## SUPPLEMENTARY COUNCIL ASSESSMENT REPORT

| <b>Panel Reference</b>   | 2017SSW012  |
| <b>DA Number</b>   | 4204/2016/DA-RA   |
| <b>Proposed Development</b>  | Demolition of existing structures and construction of a 15 storey mixed use building comprising of 85 residential units, four levels of basement car parking, one level of retail, two levels of commercial |

Figure 4: Location Plan of substation in unformalised laneway at the rear of Lot 101 DP 621692.

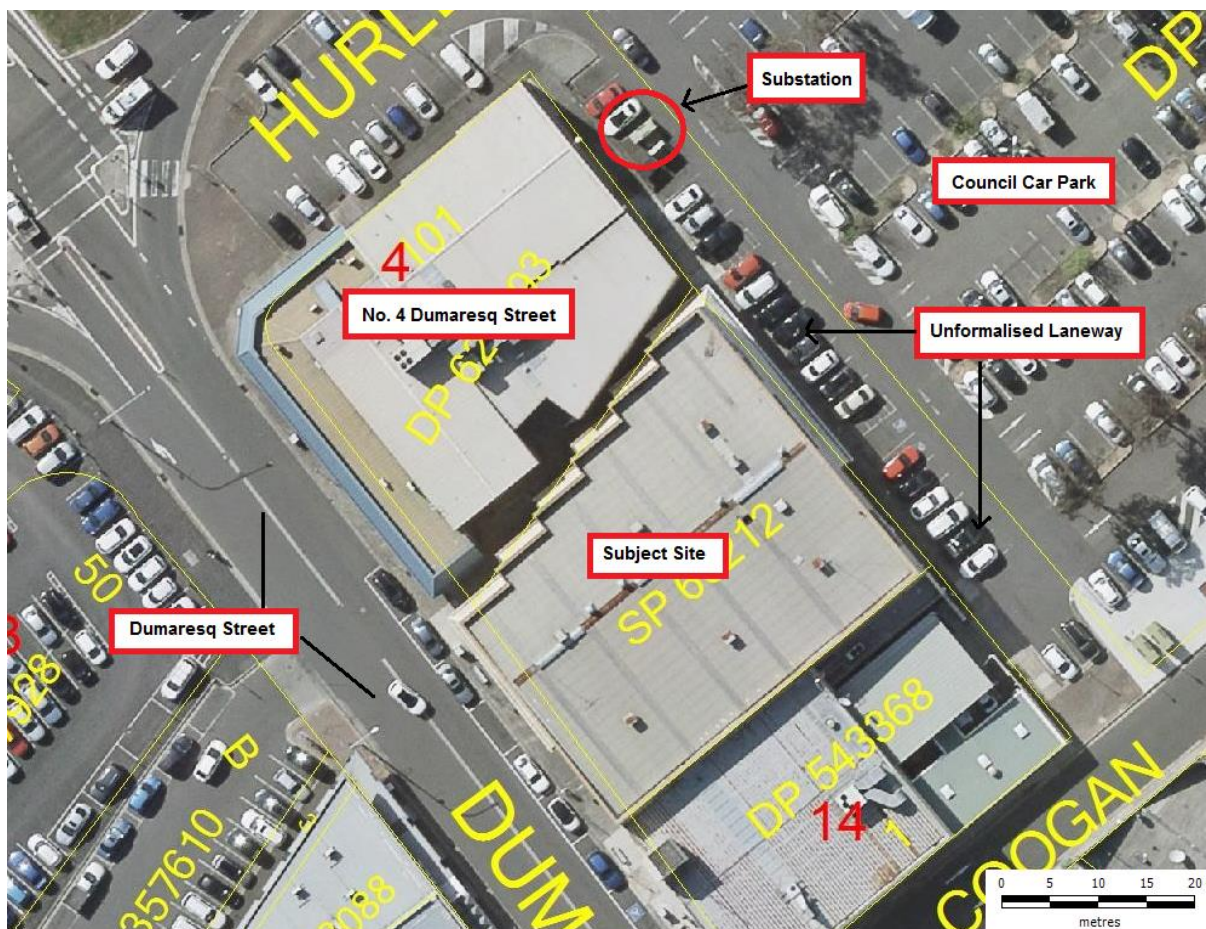
A padmount substation is located within the unformalised laneway at the rear of No. 4 Dumaresq Street, Campbelltown (Lot 101 DP 621692).

Council's Executive Manager Property advised the following in relation to the existing electrical substation:

- Formal encroachments on Lot 201 DP 785774 are a very significant issue for this community owned site, (given its anticipated future use and the associated job creation) and cannot be formalised or accepted other than in very temporary circumstances.
- No objection is raised to vehicles associated with this development, driving around the substation across Council's land at the present time.
- This position would be expected to change if or when the substation is relocated and the laneway completed within its legal alignment, or if Council commences redevelopment, or any other work, on any part of Lot 201 DP 785774.

It is Council's position that the substation will remain in the current location until such time as redevelopment of Council owned land takes place. When redevelopment takes place on Lot 201 DP 785774, Council would relocate the substation to facilitate the movement of vehicles within the unnamed laneway.

Condition no. 112 requires the substation to be relocated prior to the issue of an occupation certificate. To facilitate movement around the substation, it is recommended that condition no. 112 is deleted.

| <b>Proposed condition of Development Consent</b>  | <b>Recommendation</b> |
|---|-----------------------|
| <b>112. Substation Relocation</b><br><br>Prior to the principal certifying authority issuing an occupation certificate, the substation that is located within the unnamed, unformalised laneway at the rear of No. 4 Dumaresq Street, is to be relocated in consultation with Endeavour Energy and Campbelltown City Council, in order to facilitate egress from the site to Hurley Street. | Delete                |
